Re: Centre Wellington Hydro Ltd. 2012 IRM3 Rate Application Board Staff Interrogatories Board File No. EB-2011-0160

Board Staff Interrogatories 2012 IRM Rate Application Centre Wellington Hydro Inc. ("Centre Wellington") EB-2011-0160

A section of Sheet B1.2 – "Removal of Rate Riders" of the 2012 ICM Work Form is reproduced below.

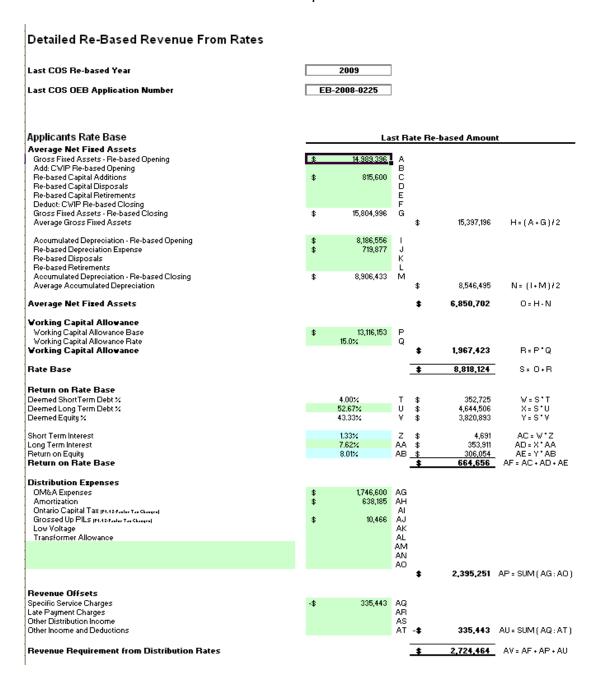
- a) Please confirm that the values entered in column D represent the \$1.00 smart meter funding adder approved by the Board in EB-2008-0225.
- b) Please confirm that the values entered in columns E and F represent the low voltage service rates for each applicable class.
